Utility Information Sheet (UIS)

PE Project No.: STA 1281-011; WBS #: 15782
CN Project No.: STA C800-001; WBS #: 16501

Project Description: 120th Avenue Connection- Phase I
Construct new 120th Avenue Connection alignment from Wadsworth Pkwy (SH 121) to Old Wadsworth Blvd. Construct new Commerce Street from Park Street to 118th Avenue. Also, minor realignment of Old Wadsworth Blvd.

UIS #: 05-001
Utility Company: Dry Creek Valley Ditch (Public)

| Print Date: 5/5/2008 | | Sheet Revisions | | | Colorado Department of Transportation | | As Constructed | | 120TH AVE. CONNECTION UTILITIES | | Project No./Code | |

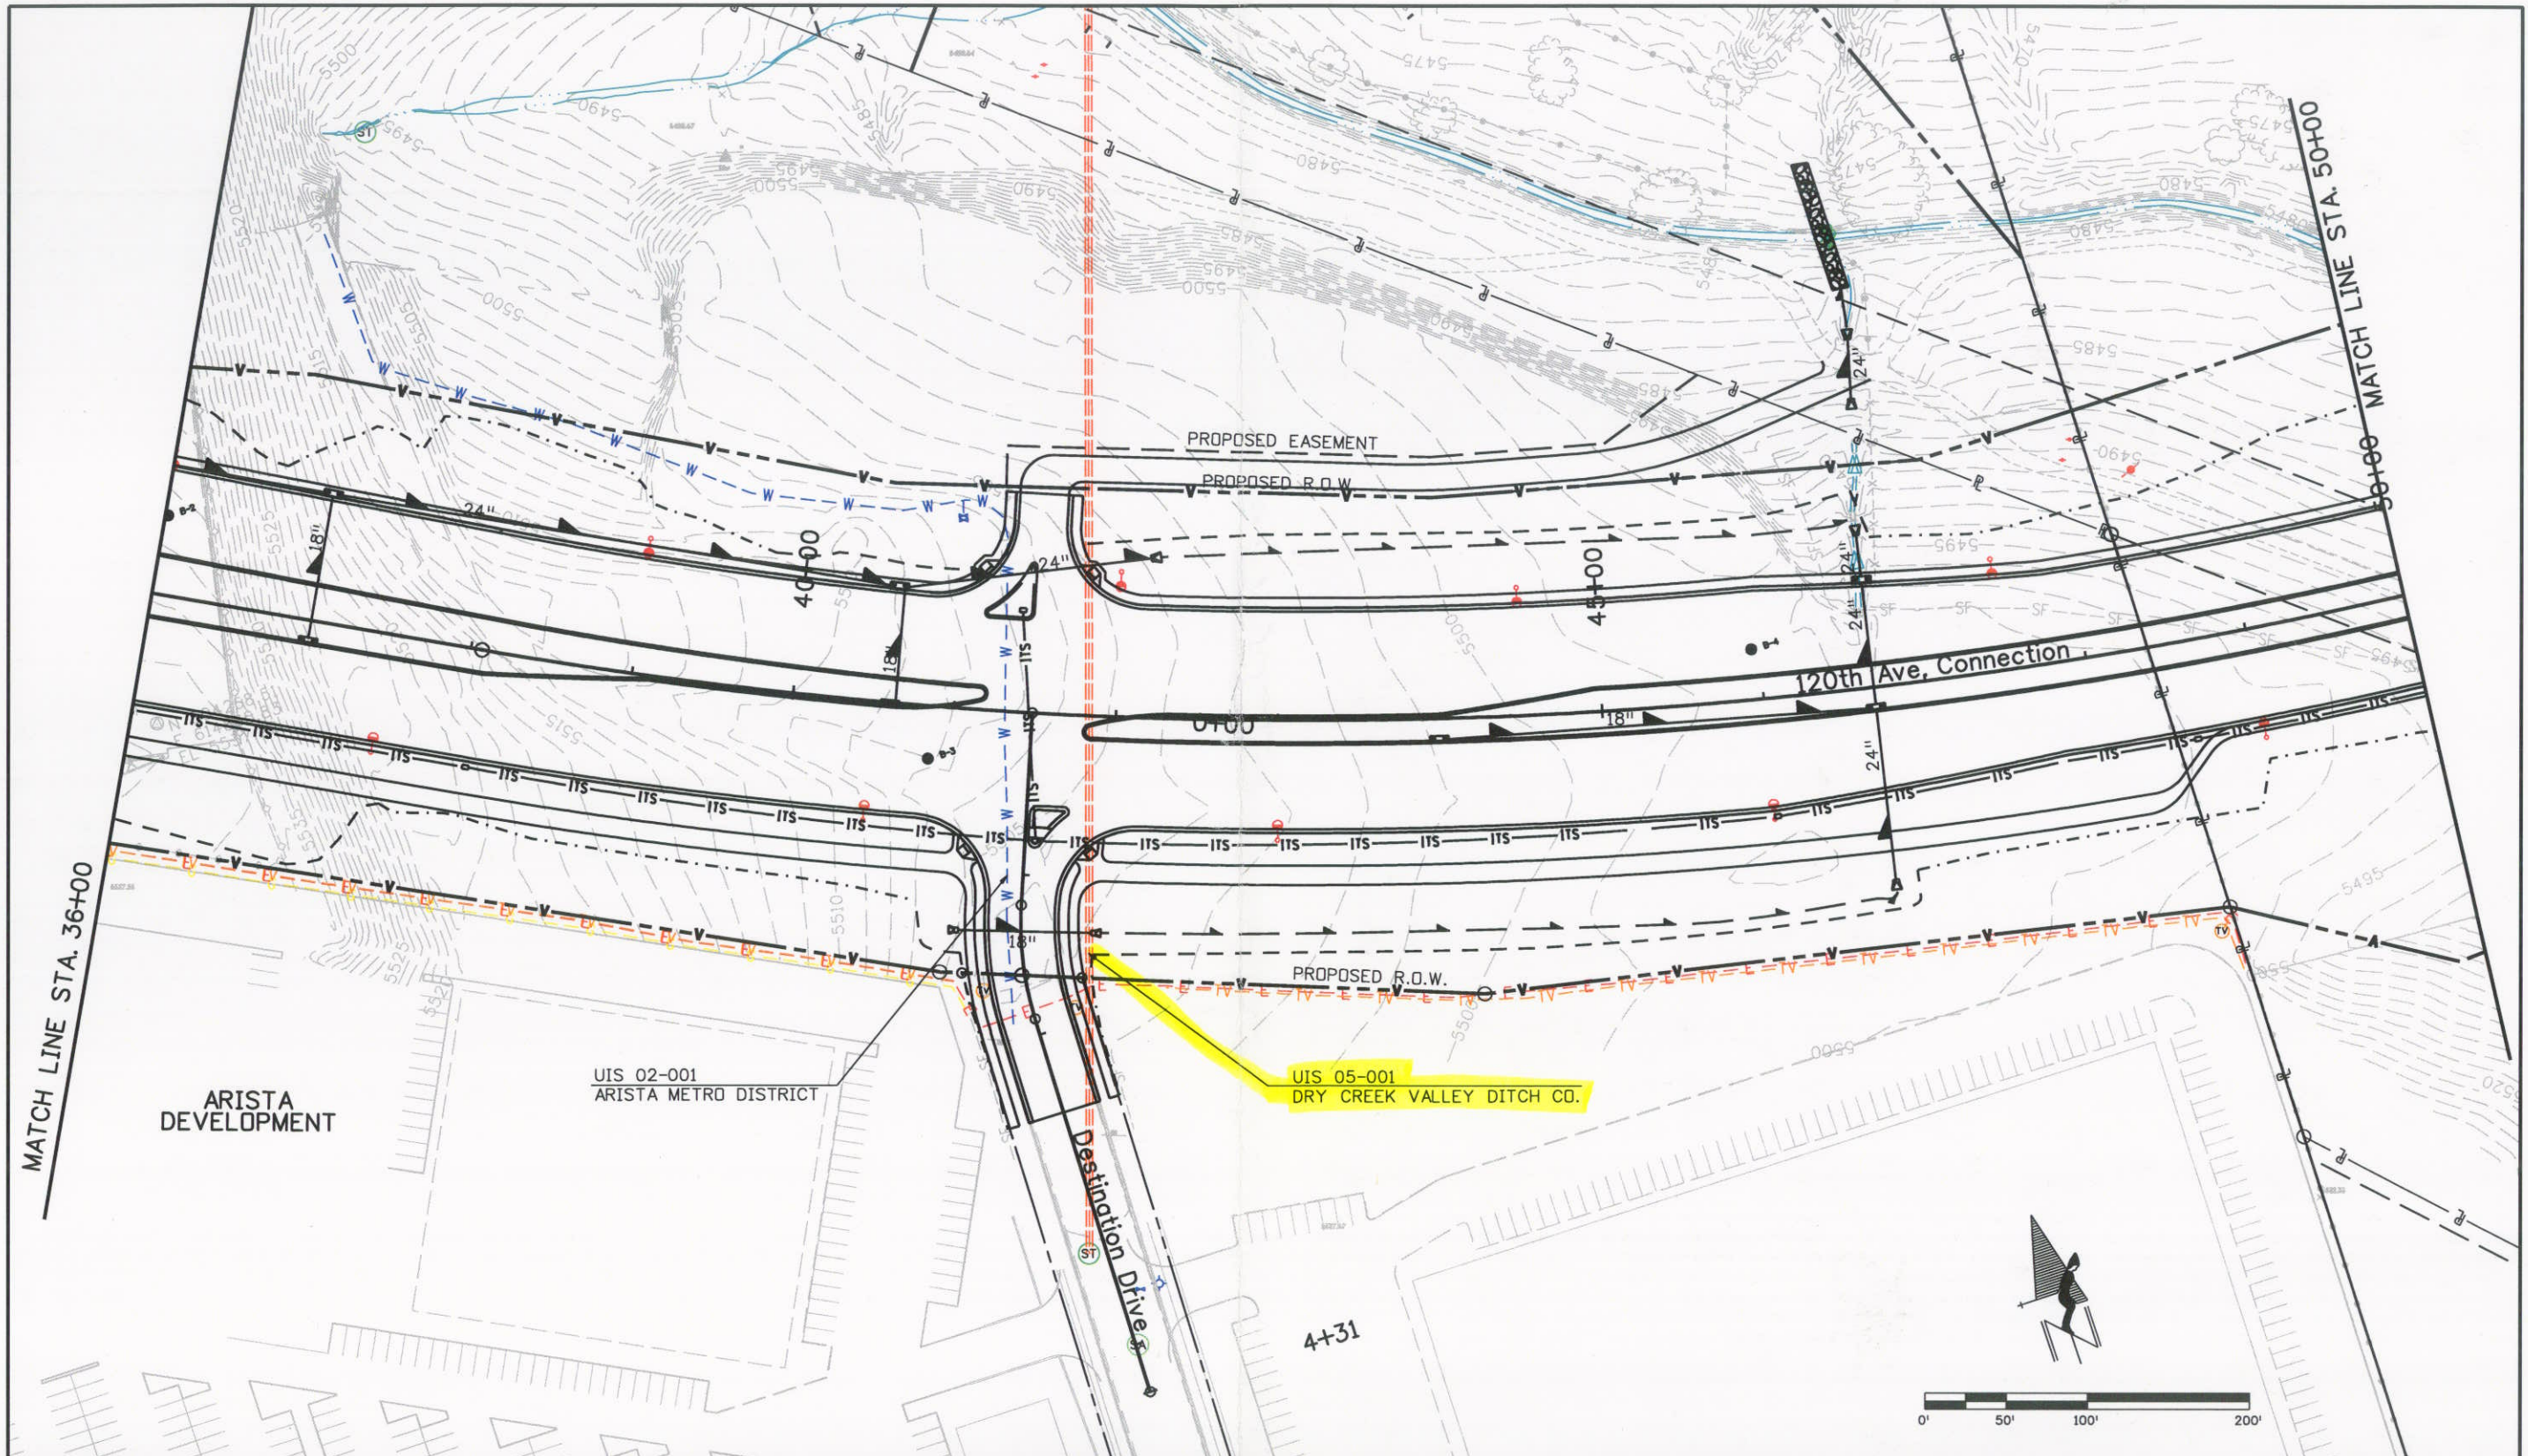
Expected Impact: None-Contractor shall avoid impacts to this facility.

THERE SHOULD BE NO DIRECT IMPACTS TO THE DRY CREEK VALLEY DITCH PIPELINE RESULTING FROM THE CONSTRUCTION OF CDOT'S 120TH AVENUE CONNECTION PROJECT. HOWEVER, THERE ARE IMPACTS RESULTING FROM THIS CONSTRUCTION IN AREAS SUCH AS ACCESS FOR PIPELINE REPAIRS OR REPLACEMENT. THESE IMPACTS WILL NEED TO BE ADDRESSED IN THE LICENSE AGREEMENTS AS DISCUSSED.
